## Modified Stage 1 Abatement Plan Proposal for the Mosaic Potash Mine

*Mosaic Potash Carlsbad, New Mexico*

21502059-2-R-0

September 20, 2022

**TITLE**  
 POTENTIOMETRIC SURFACE OCTOBER 2020  
 SOUTHERN AREA OF THE SITE

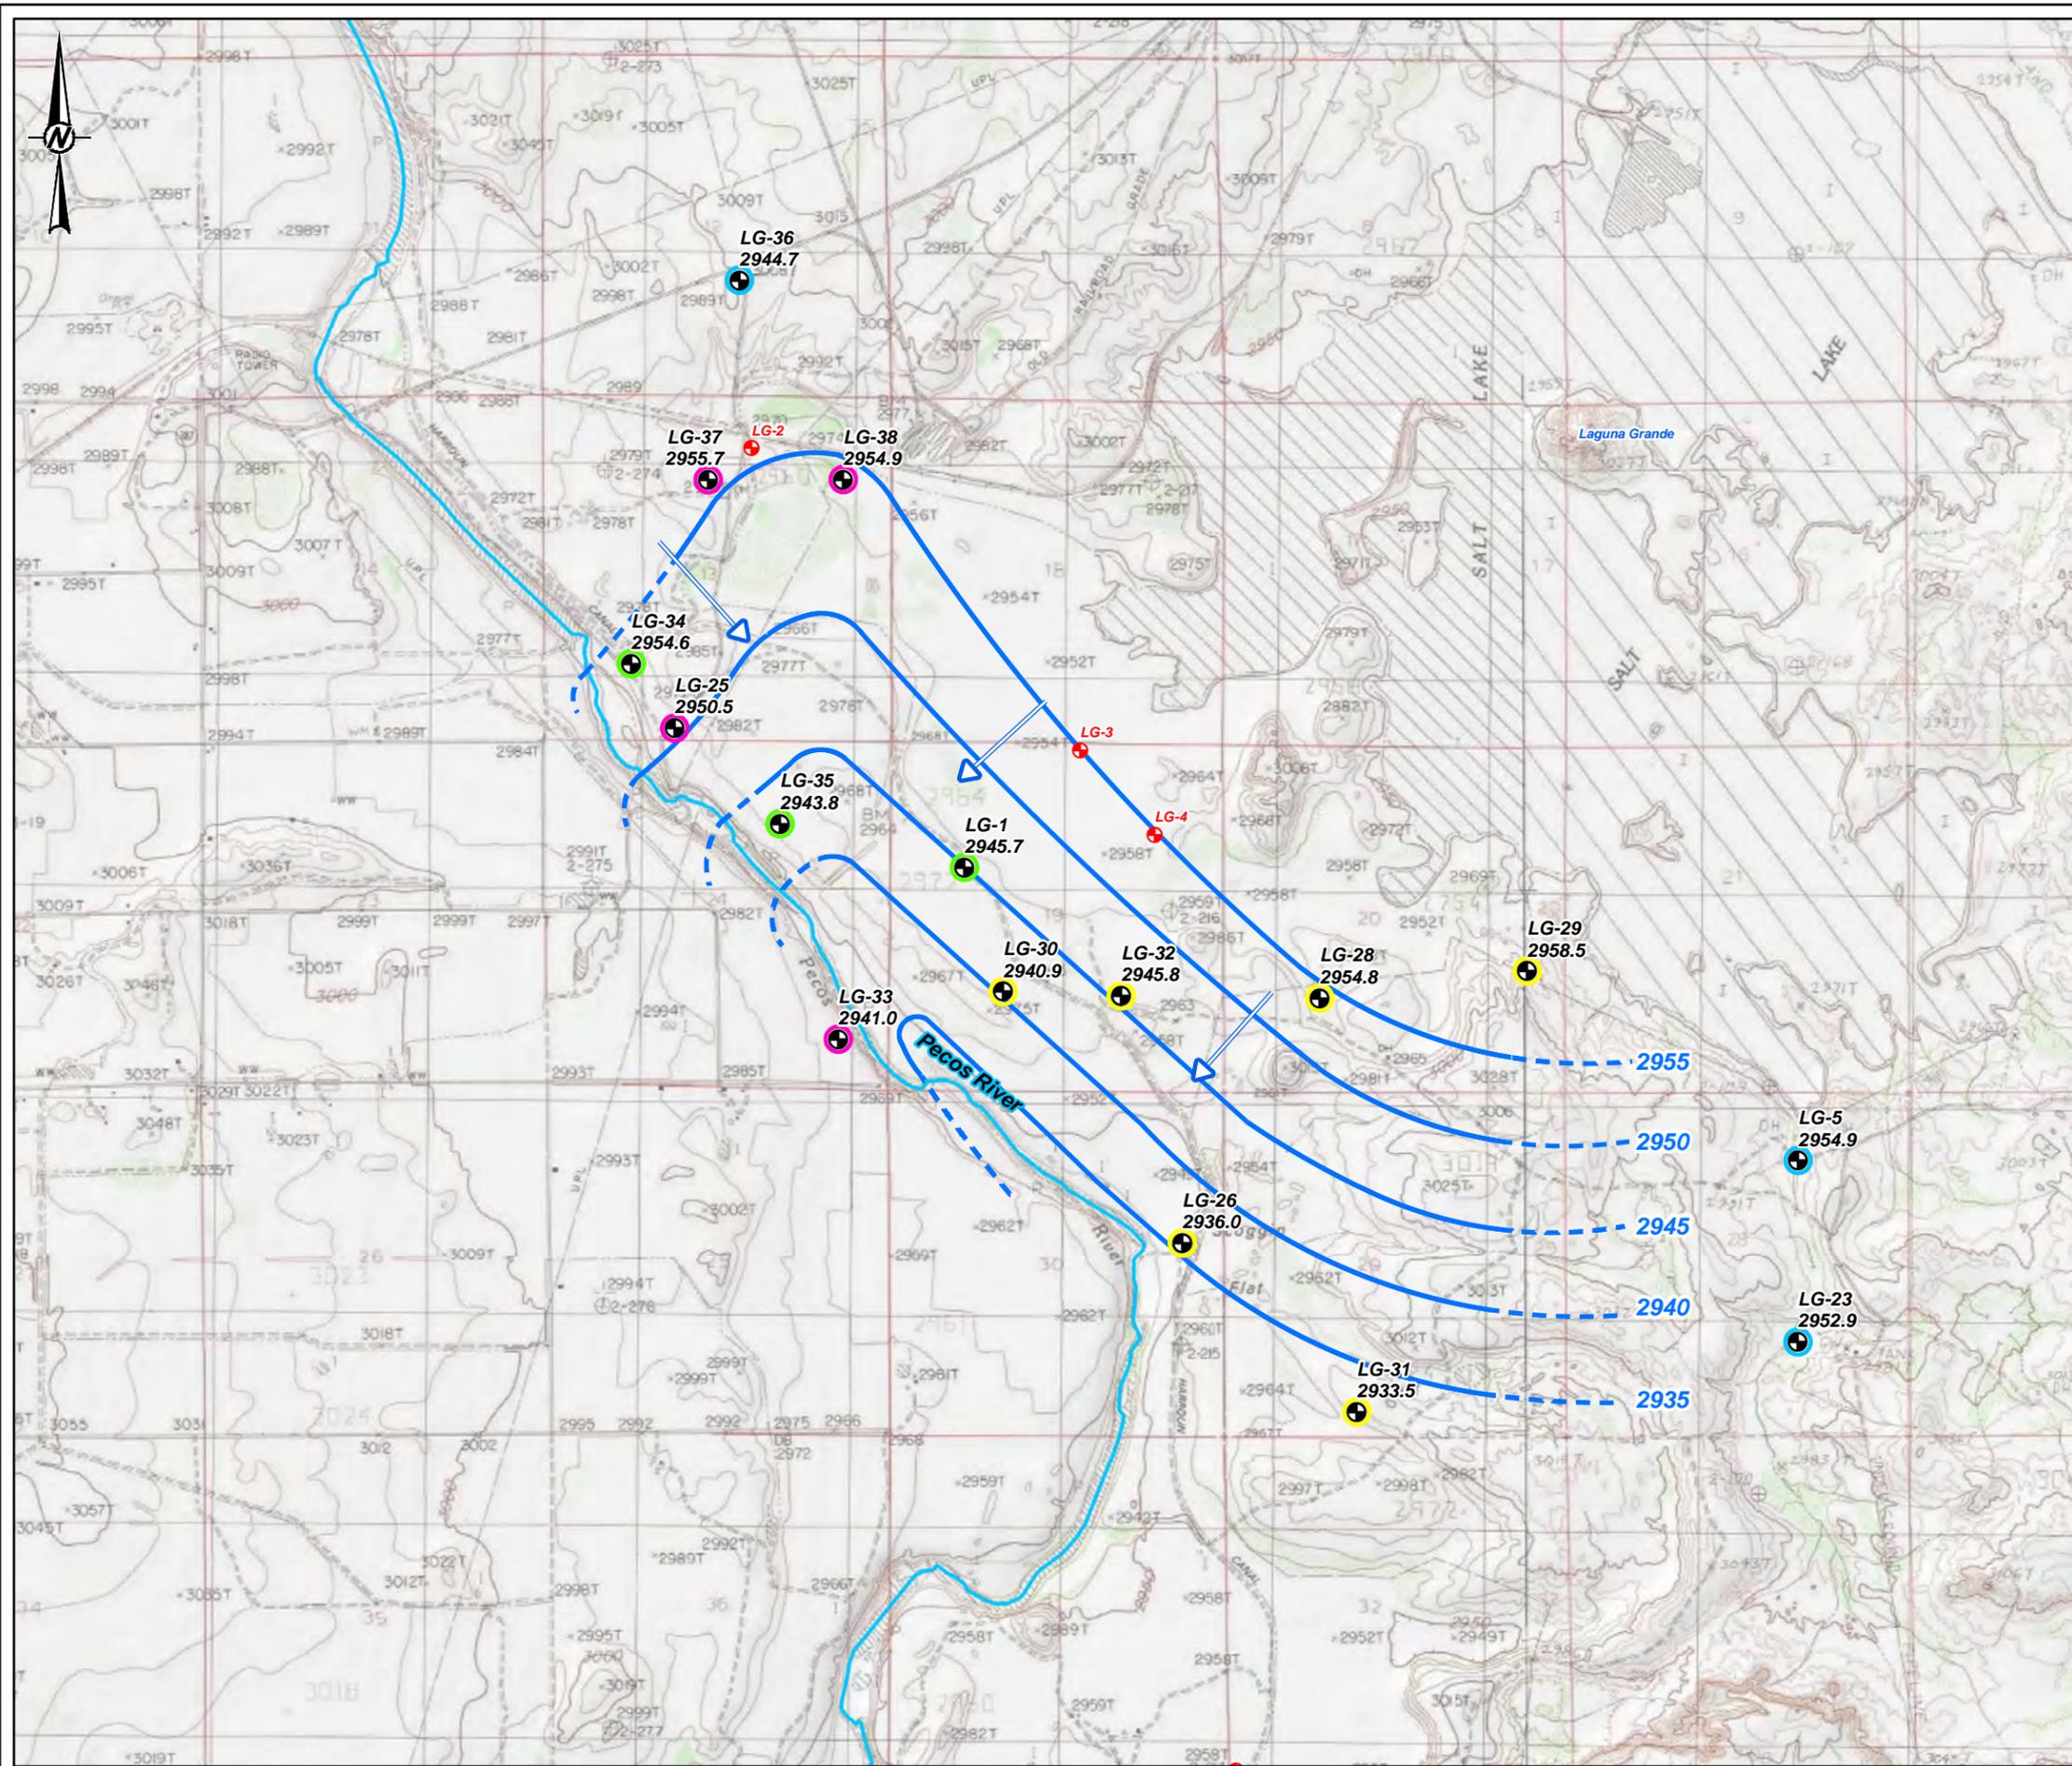
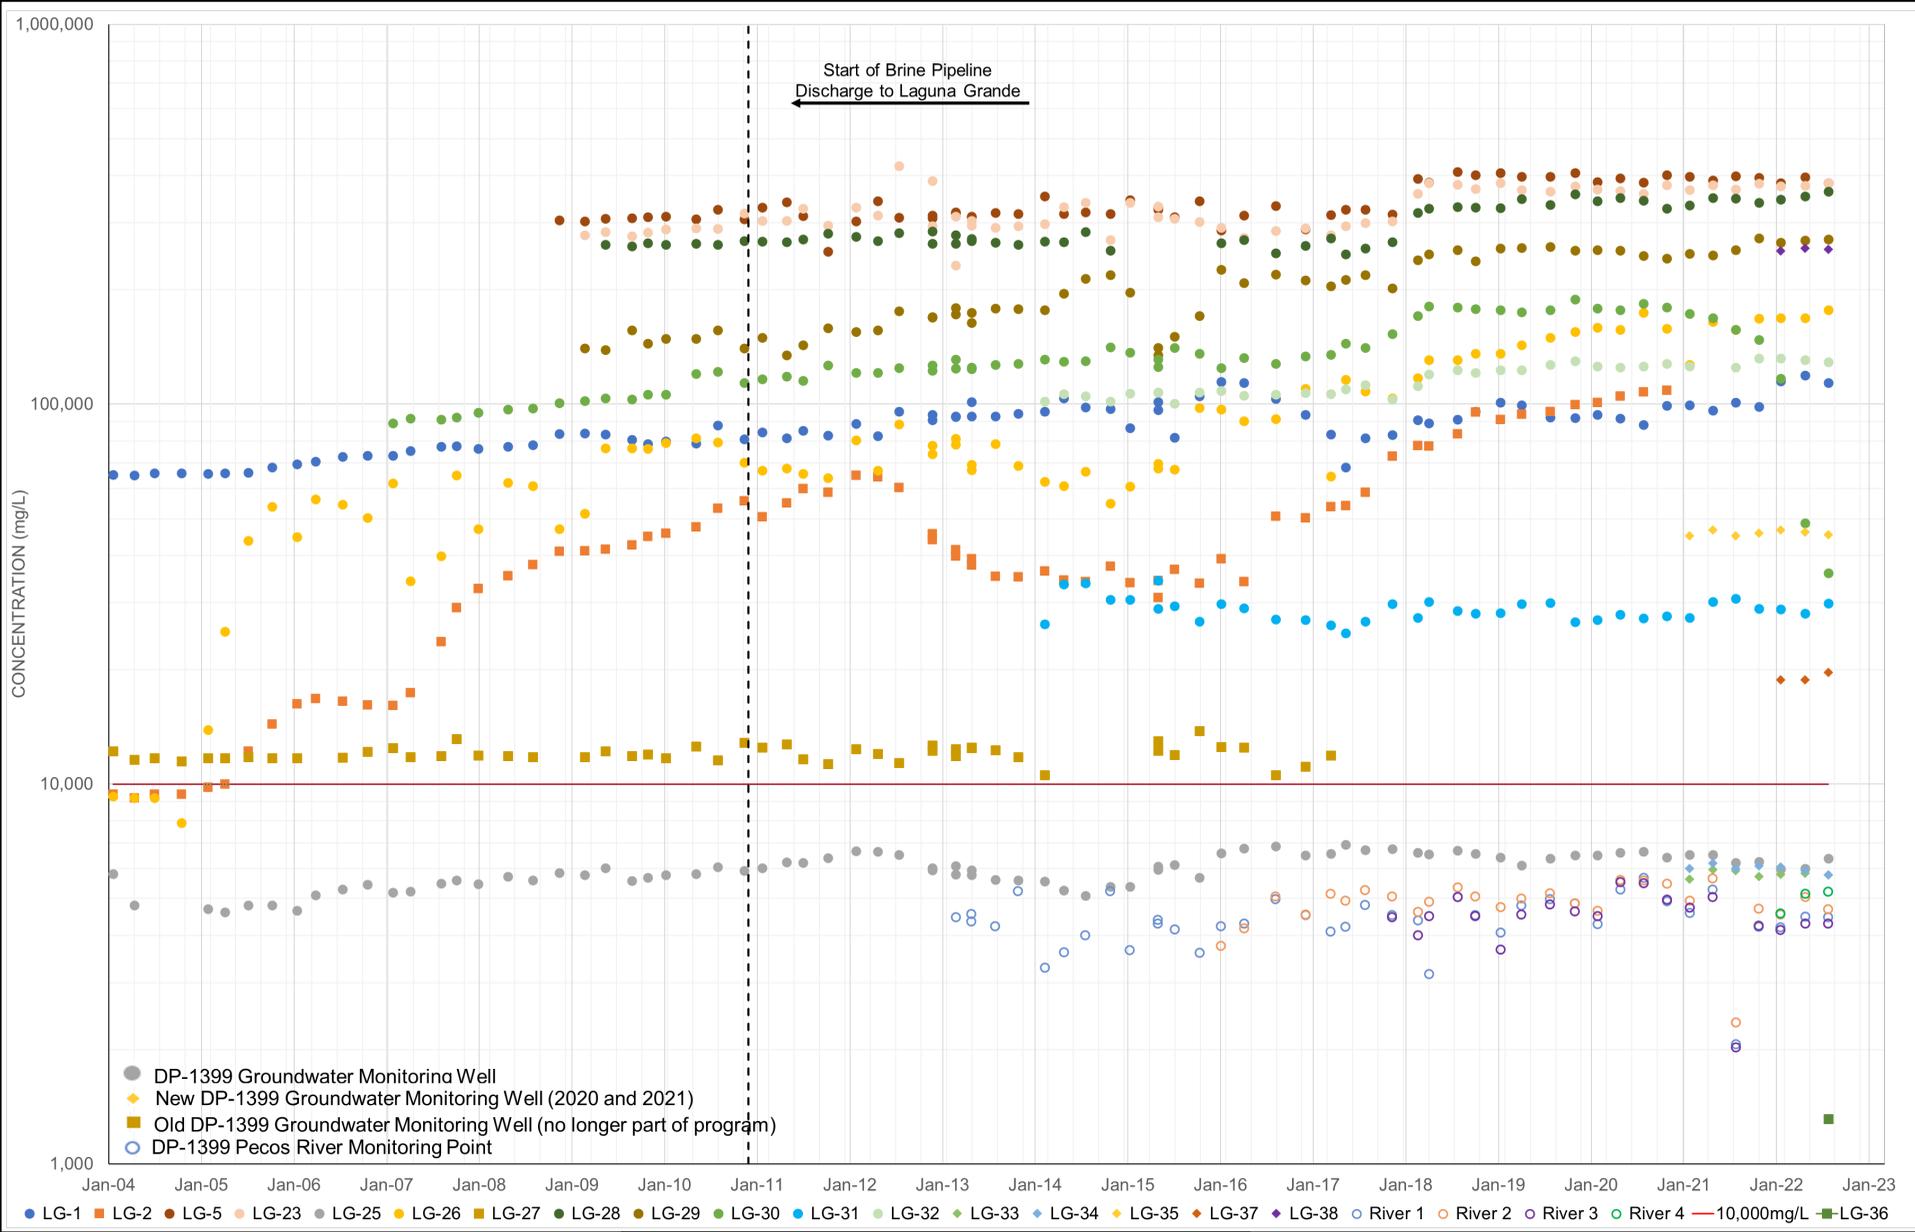
- D. Given that LG-33 is the only groundwater monitoring well the Permittee is monitoring on the west side of the Pecos River and Figures 15 and 16 in the March 21, 2022 S1AP show inconsistencies in the potentiometric surface, the Permittee shall provide a workplan to evaluate the need for additional monitoring wells on the west side of the Pecos River.

Zoomed-In Section of Plate 1 – Water Table Contour Map (GA, 1979) Showing Nash Draw Playa Lakes

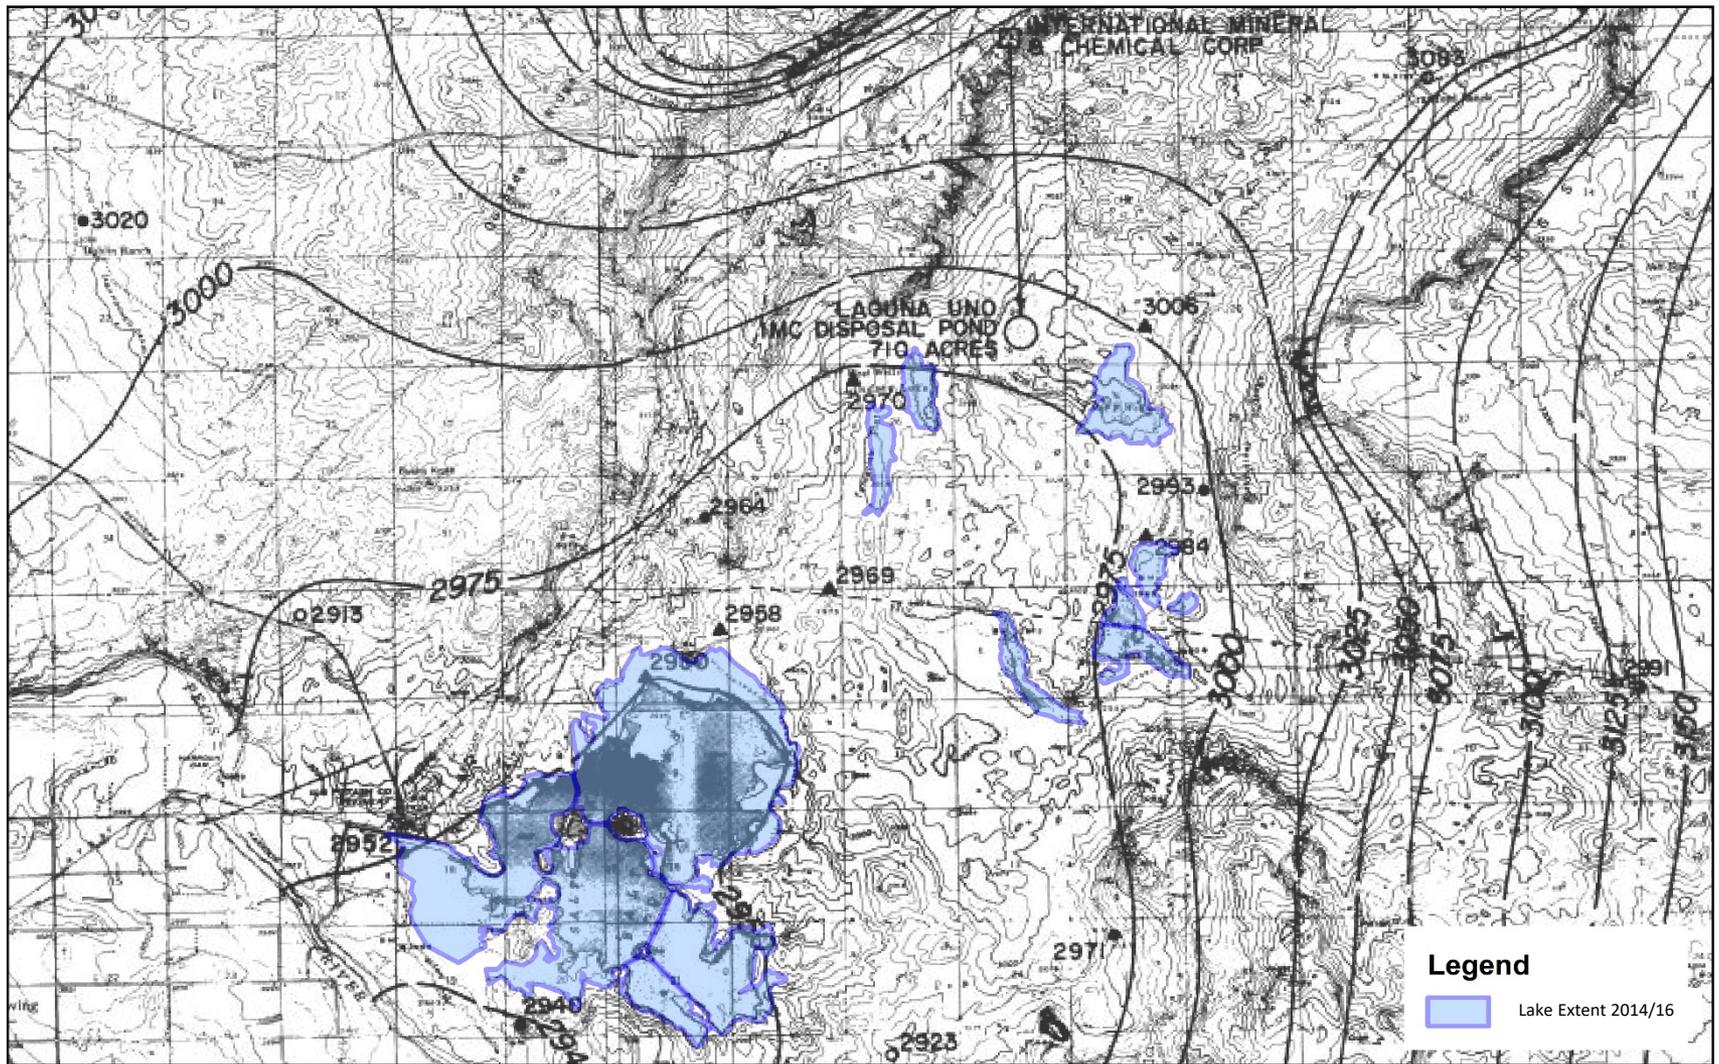
This assertion of Mr. Goodbar's is unsupported because it is contradicted by water table contour mapping (GA, 1979). Figure 1, attached, is an exact copy of a zoomed-in section of "Plate 1 – Water Table Contour Map" from the GA 1979 report on which we have highlighted the Nash Draw playa lakes including Lagunas Uno, Dos, Tres, Cuatro, and Grande for clarity. The water table contours shown on Figure 1 indicate locations of equal groundwater pressure (aka hydraulic head). Because groundwater flows from locations of high to low pressure, the hydraulic gradient direction is oriented perpendicular to the water table contour lines. The water table contour lines on Figure 1 therefore show the hydraulic gradient at Laguna Uno is oriented to the southwest toward Laguna Grande and not to the south toward Laguna Dos as asserted by Mr. Goodbar. The water table contour lines shown on Figure 1 also show that the hydraulic gradient at Laguna Dos is oriented due west toward Laguna Grande and not to the south toward Laguna Cuatro as asserted by Mr. Goodbar. Mr. Goodbar omitted this information from his report. Therefore, Mr.
